## Wollongong Local Planning Panel Assessment Report | 5 September 2018

<b>IHAP No.</b>	Item 3
<b>DA No.</b>	DA-2017/1306
<b>Proposal</b>	Commercial - alterations and additions to existing club building and multi-level car park
<b>Property</b>	61 Church Street Wollongong; Lot 103 DP 1148604
<b>Applicant</b>	New England Constructions Pty Ltd
<b>Responsible Team</b>	Development Assessment and Certification - City Centre Team (TW)

### ADDENDUM REPORT AND RECOMMENDATION

Drawing Title  
**PROPOSED SITE PLAN - GROUND FLOOR**

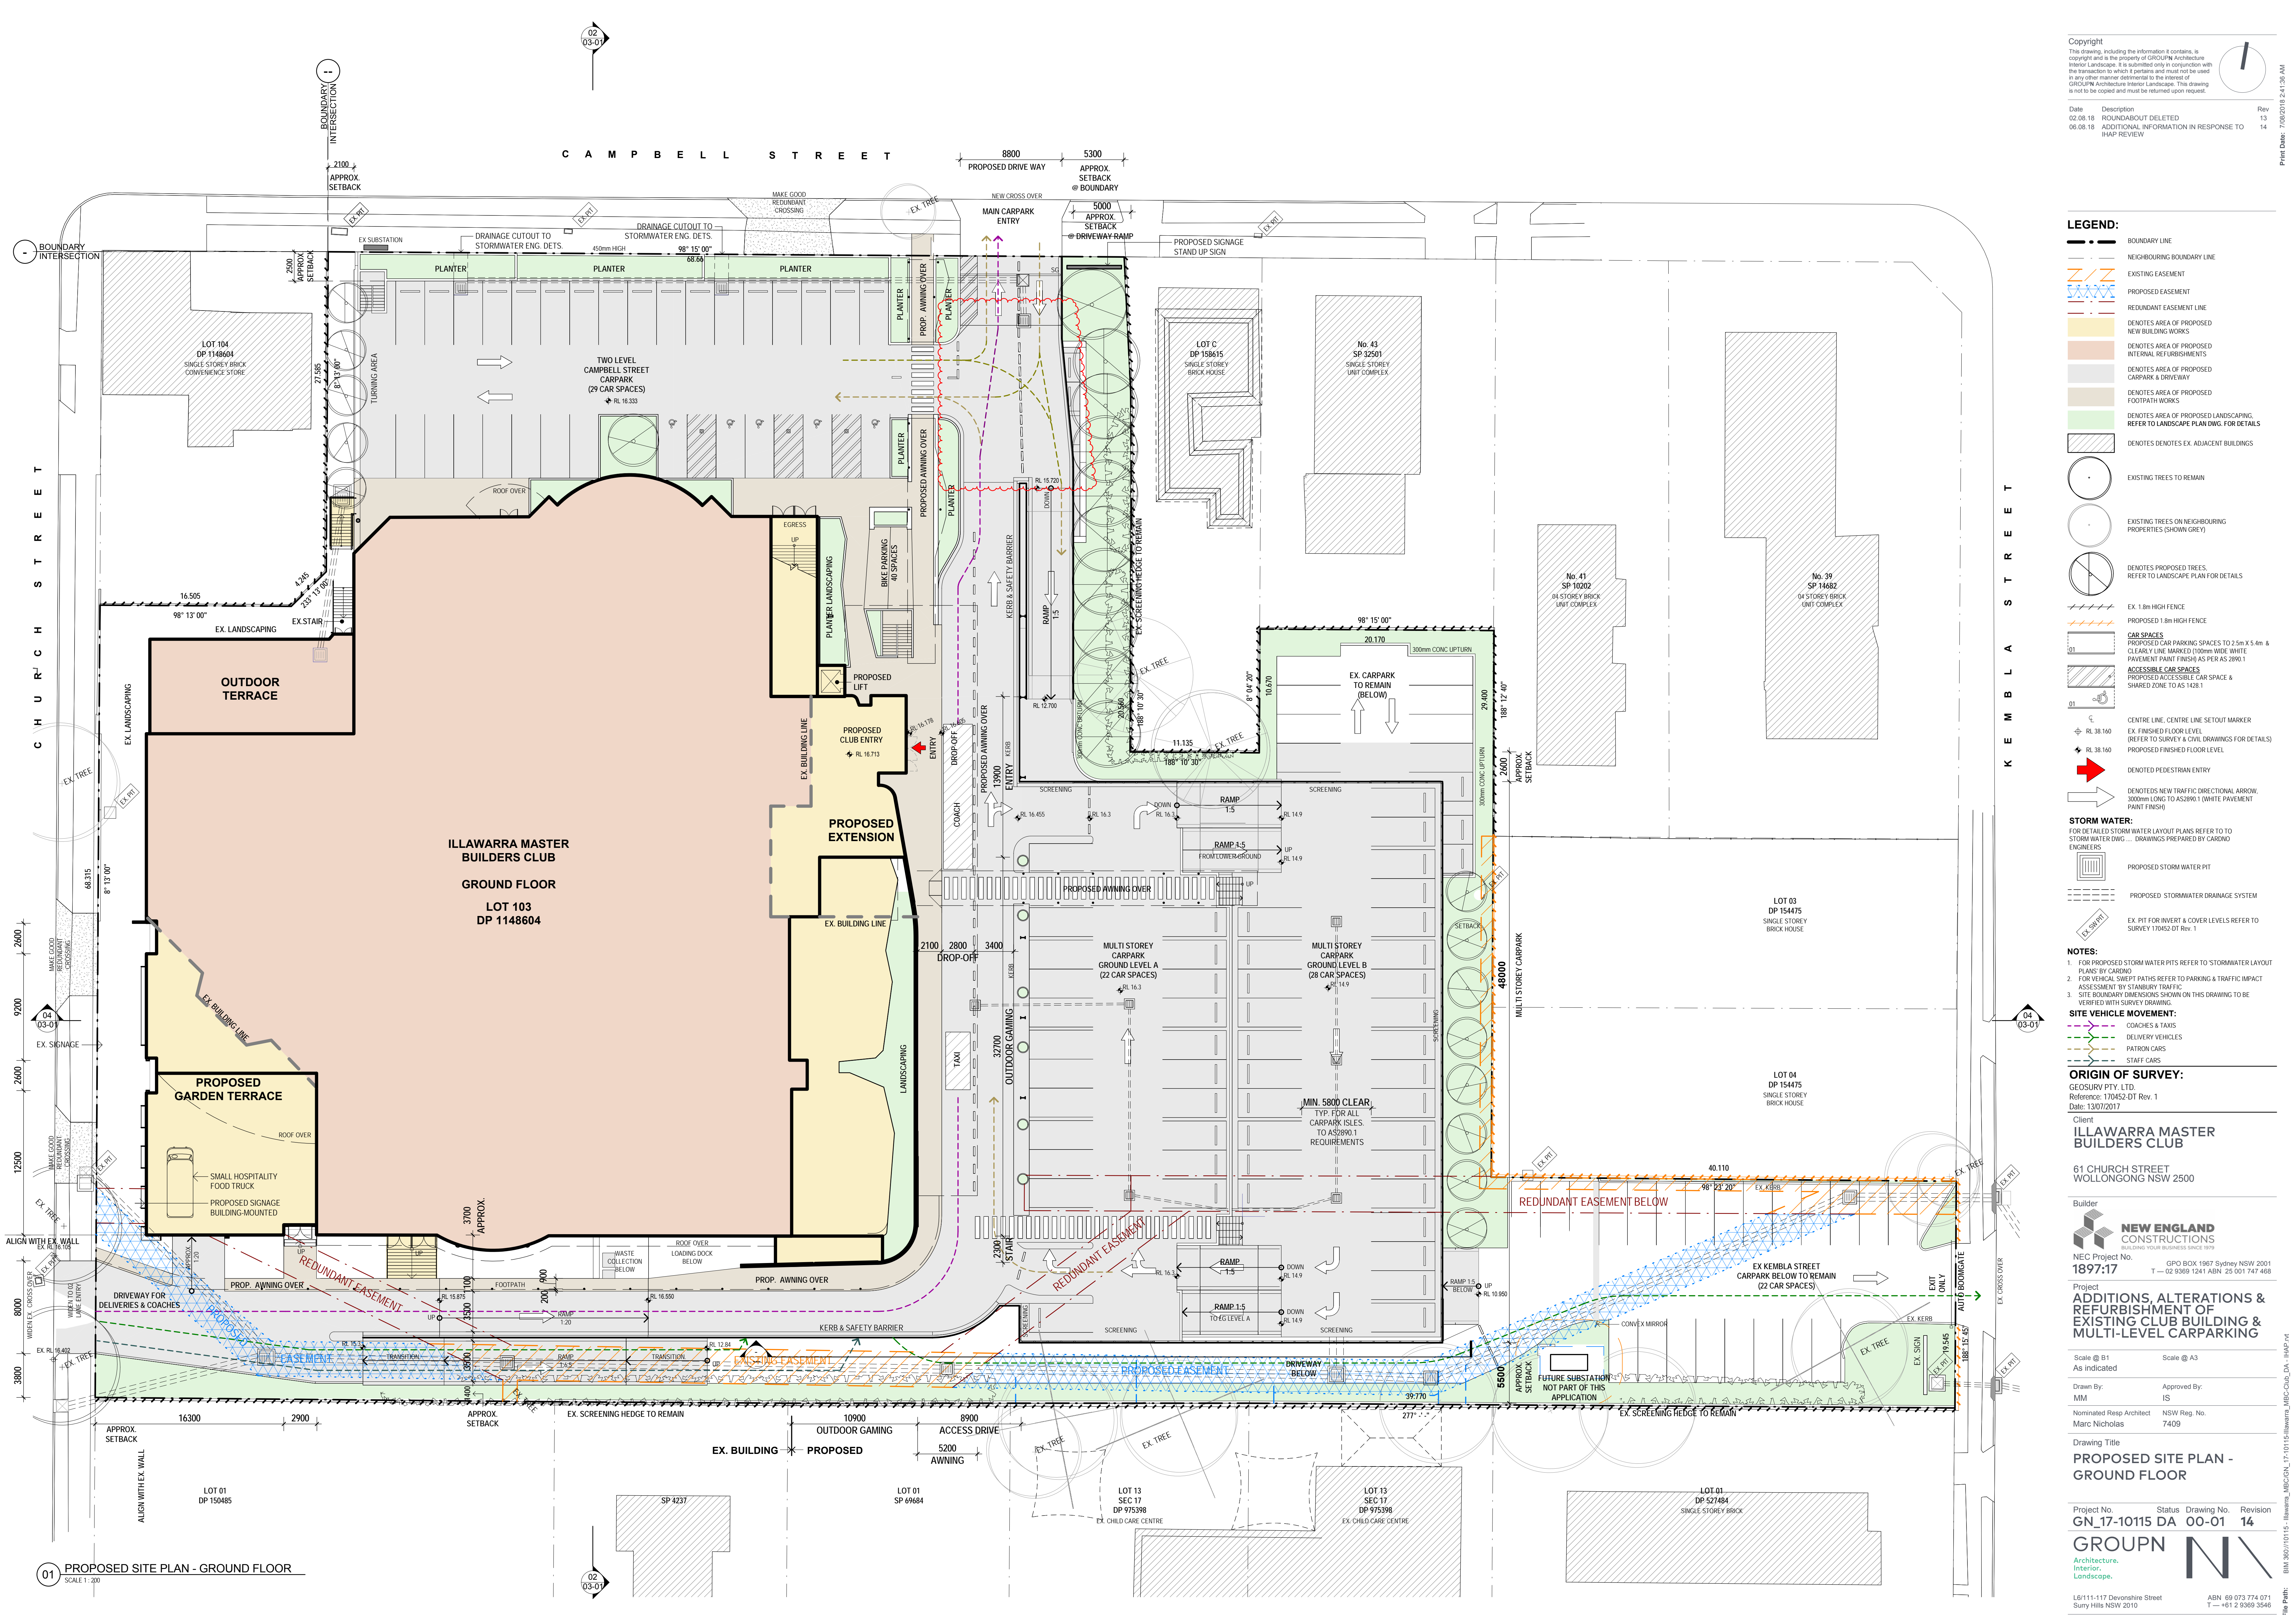
However, the applicant has acknowledged the concerns of the WLPP and residential neighbours at 45 Campbell Street to the immediate east of the site and has amended the design. The amended site plan has deleted the roundabout (featured in the earlier plans) from inside the Campbell Street frontage and has replaced it with a standard 'T intersection'. This has increased the setback from the eastern edge of the driveway to the common boundary with the neighbouring property. This will now allow a setback of the driveway structure of approximately 4m over its entire length from the eastern boundary. The lower floor carpark remains unchanged, with the height of the retaining wall in this location finishing at ground level. The increased setback allows for additional planting to be provided between the driveway and the eastern boundary of the site.

Date	Description	Rev
02.08.18	ROUNDAABOUT DELETED	13
06.08.18	ADDITIONAL INFORMATION IN RESPONSE TO IAP REVIEW	14

Drawing Title  
SECTIONS, S & NE  
BOUNDARY

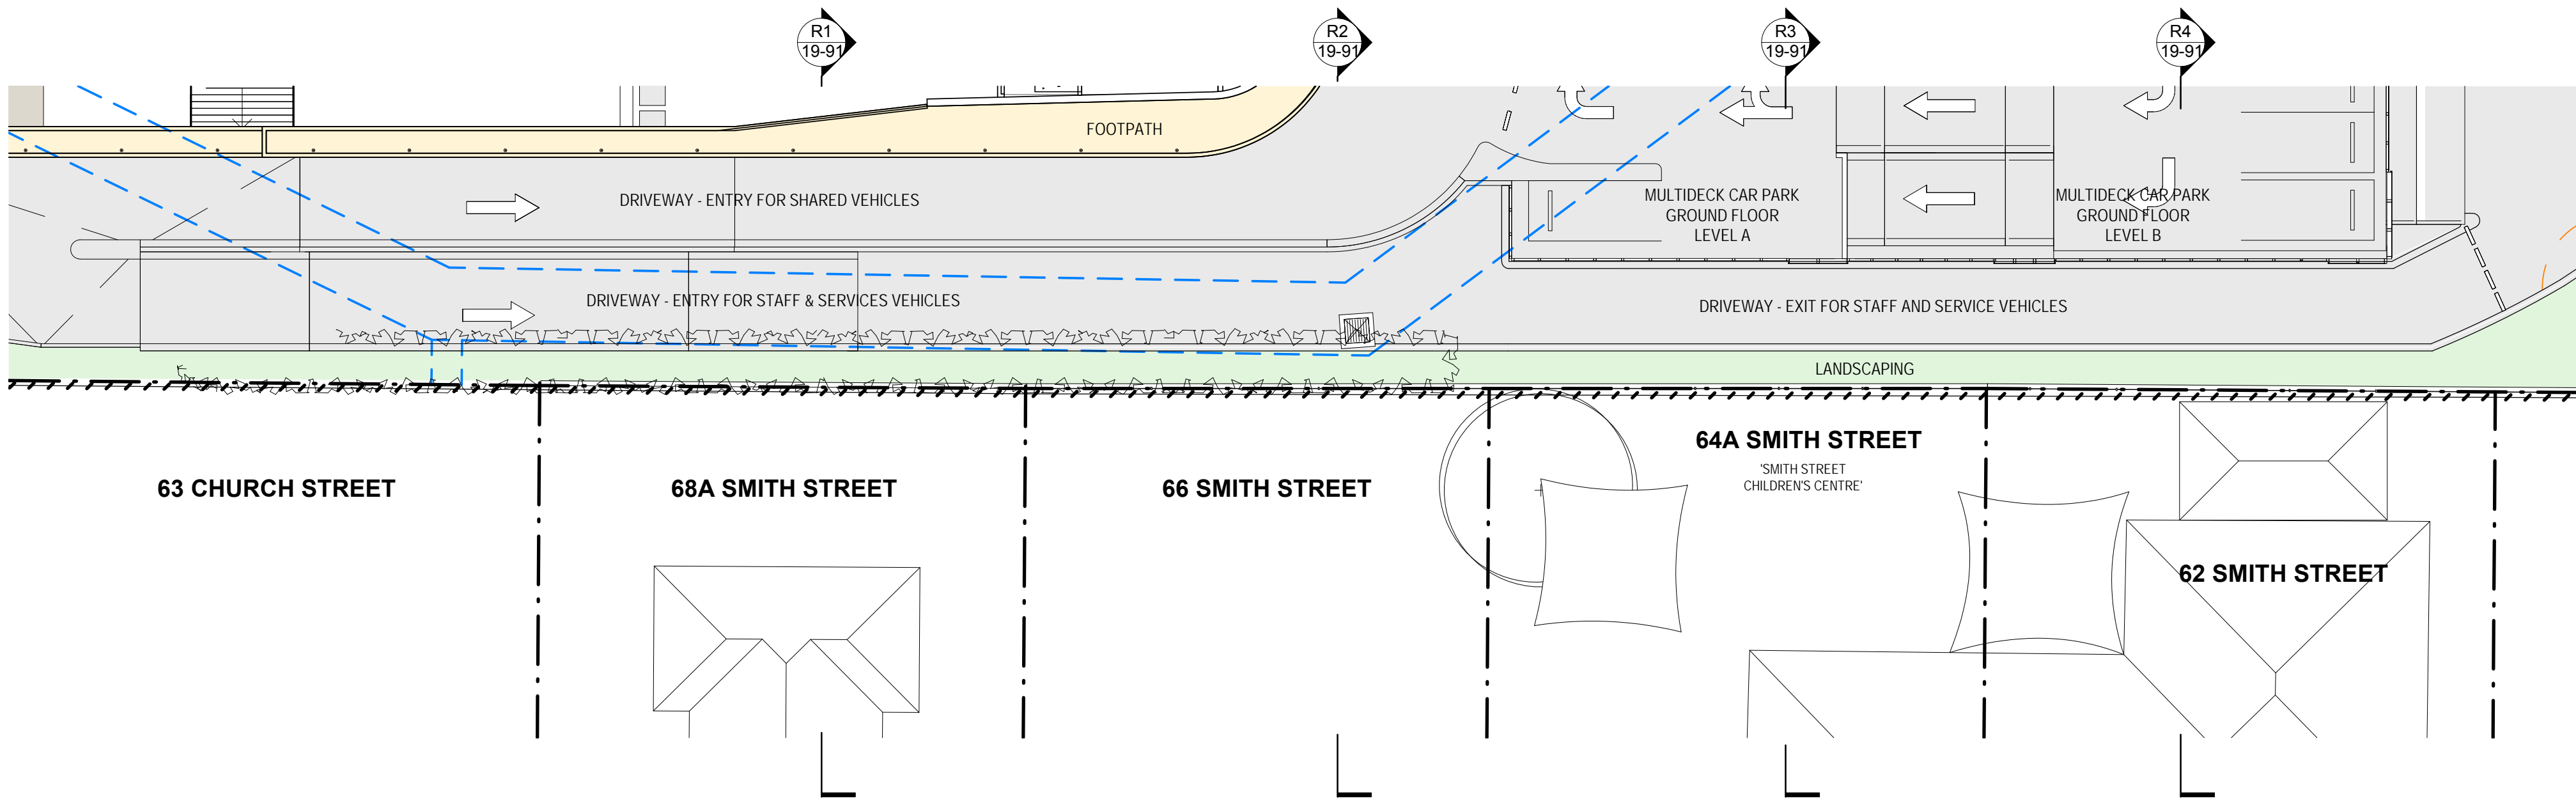
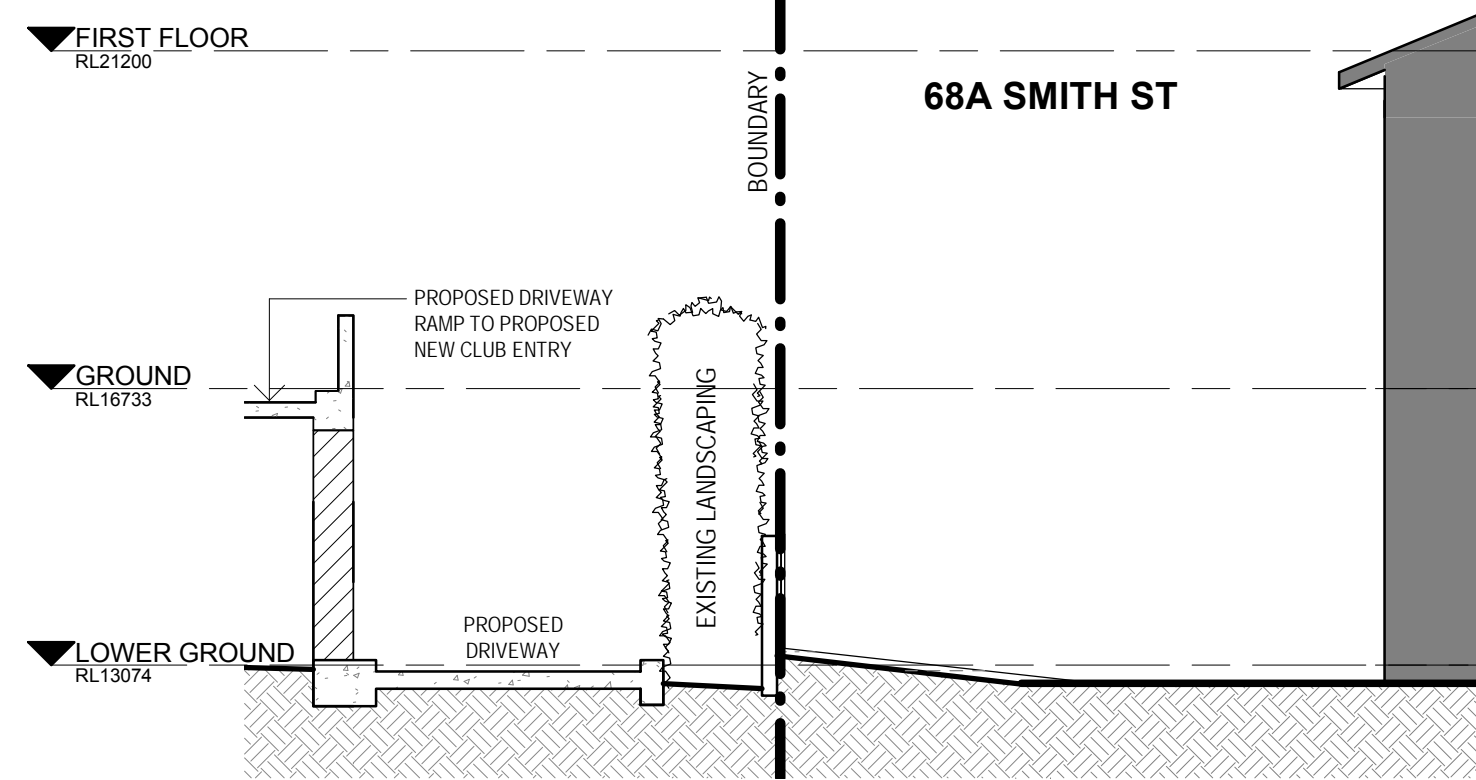
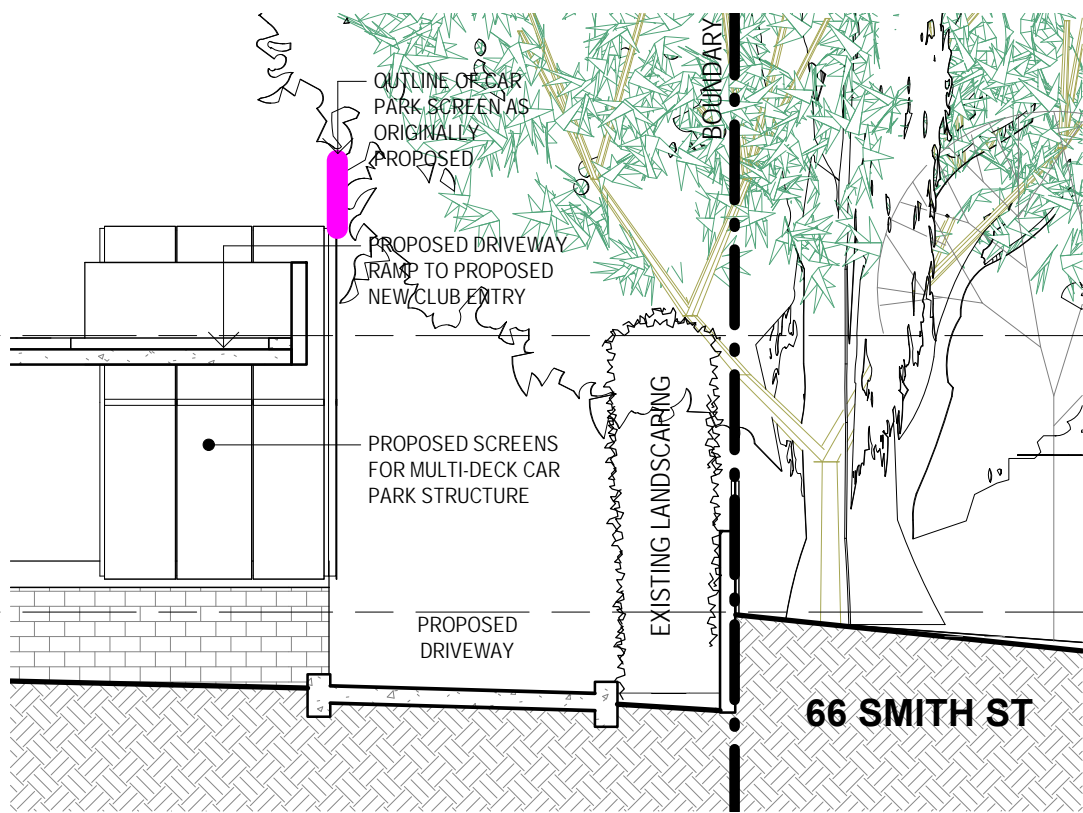
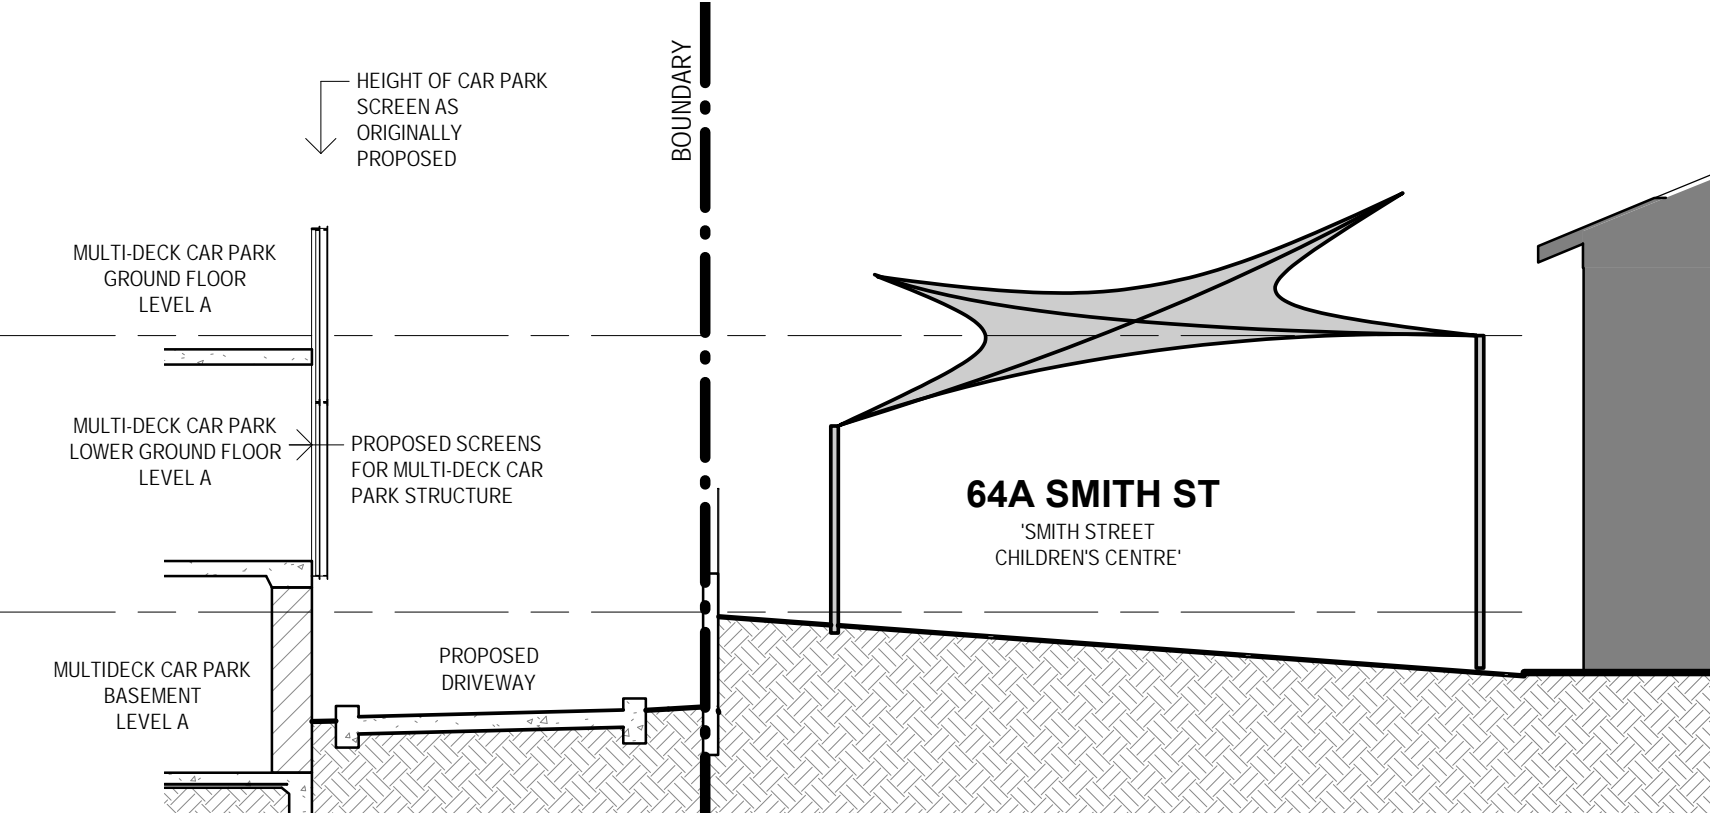
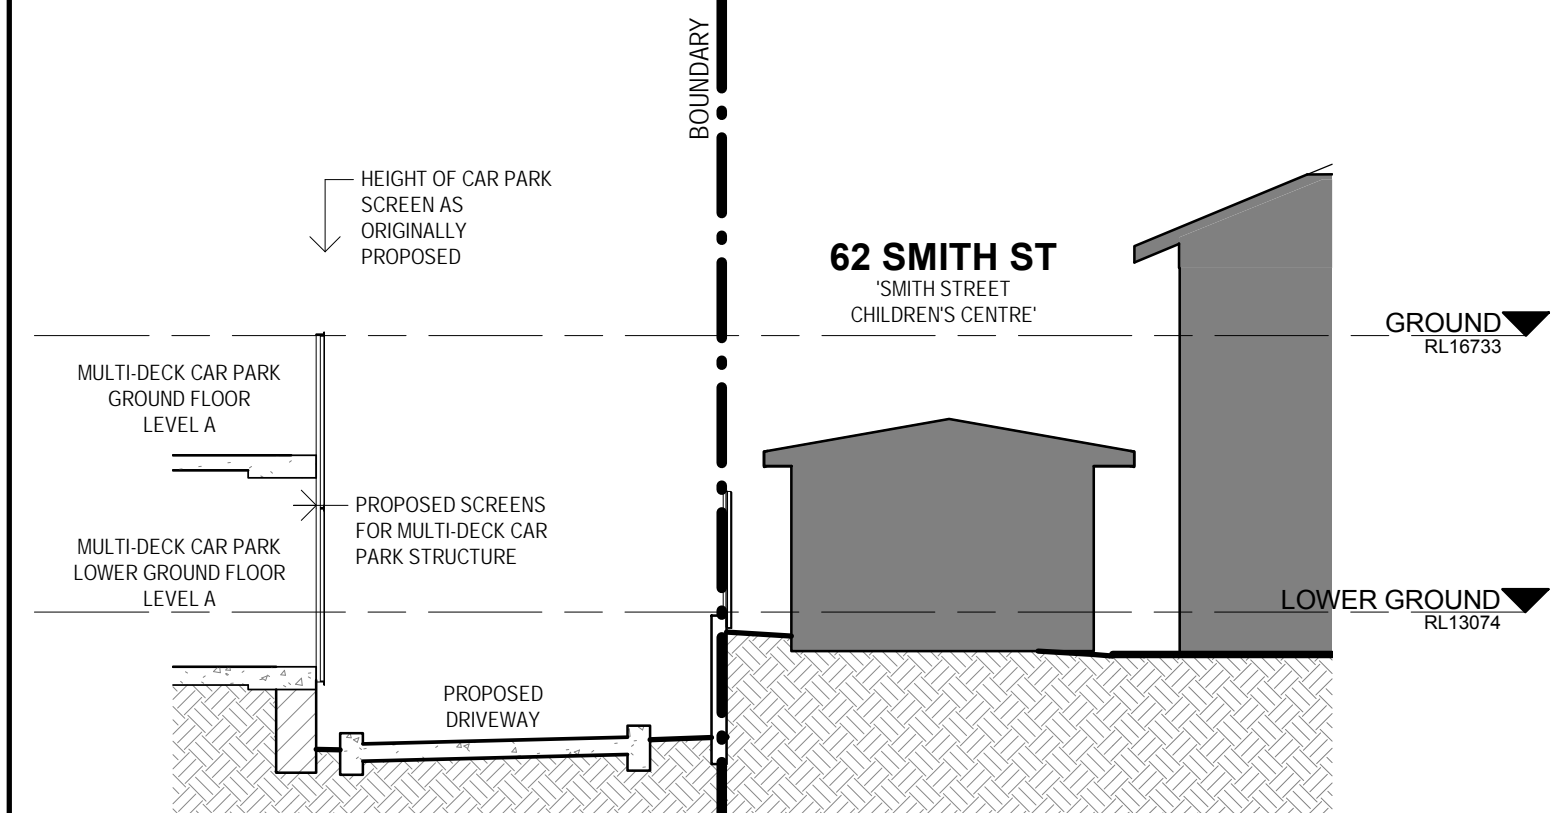
The applicant has advised that the height of the Campbell Street (northern) driveway is unable to be changed as the height has been set so as to provide minimum clearance for car parking underneath at the Lower Floor Level. This Level is already as low as possible as the car park will include use of the existing concrete slab of the Club building's lower floor area.
